PERMIT

SEWAGE DISPOSAL SYSTEM

HOWARD COUNTY HEALTH DEPARTMENT

SUBDIVISION Meadowood LOT 15 ROAD 12100 Mayapple Trail

MAYAPPLE DR INDICATE NORTH - NAME ADJOINING ROADWAY AS BASE LINE

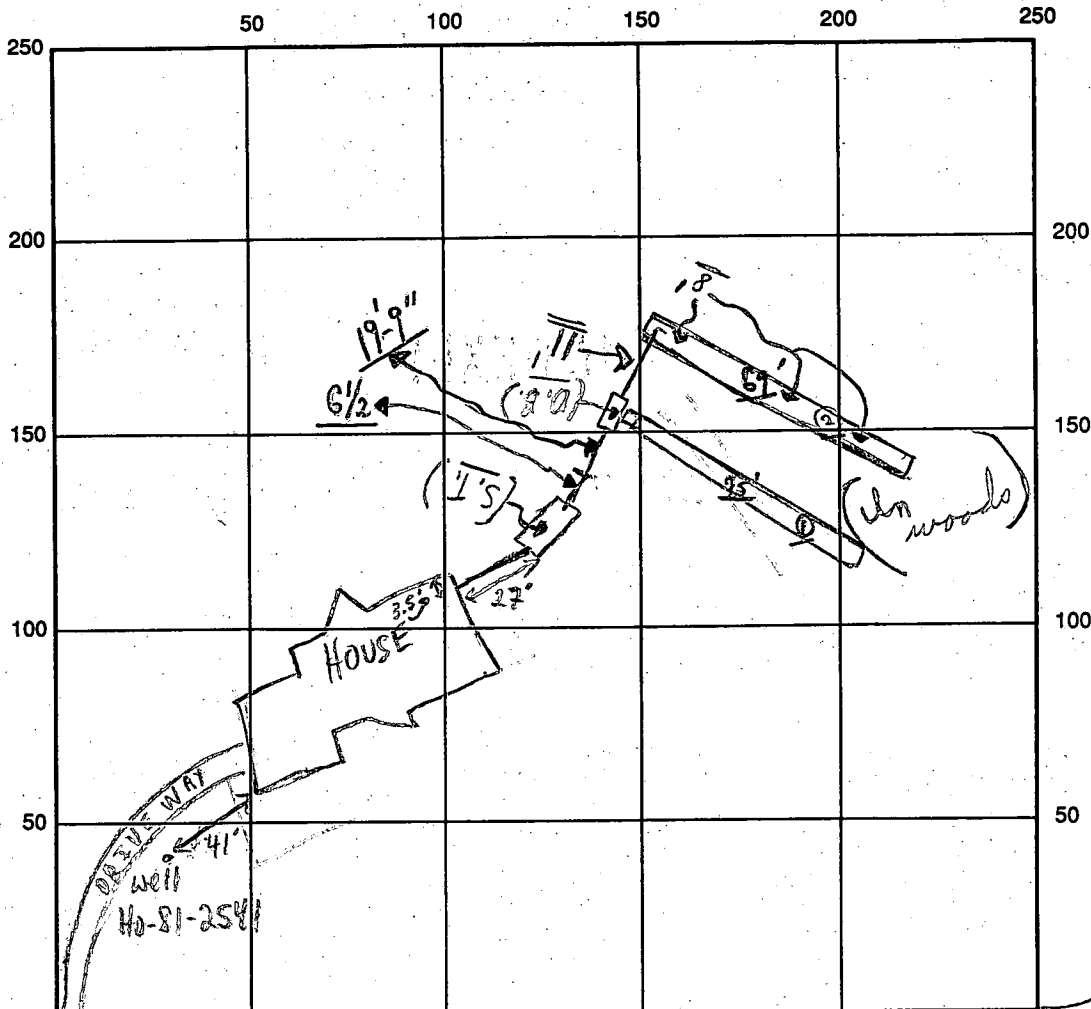
SEPTIC TANK LEVEL 1250 GAL-OK CLEANOUTS S.I.T. / OK

DISTRIBUTION BOX LEVEL ## OK (Baffle is in)

DRAIN FIELD/TITLE DEPTH 8 1/2 FT. TRENCH WIDTH 2 FT. INLET DEPTH 3 1/2 FT.

EFFECTIVE GRAVEL DEPTH 5 1/5 FT. TOTAL LENGTH ① 25' ② 69' FT. = (144)

REMARKS: 10/22/92 #1 OK TO CONTINUE, TRENCH ① TO BE EXTENDED TO 65'
P.M. 10/22/92 - Partial - ok to continue; ok for stone in #② trench.
ok to cover from houses to tank - only; and to cover #① trench only
10/23/92 HOLD FOR A CALL, AM. OK TO COVER AS FINISH - Final 10/23/92.
(Material on site) C. Bel
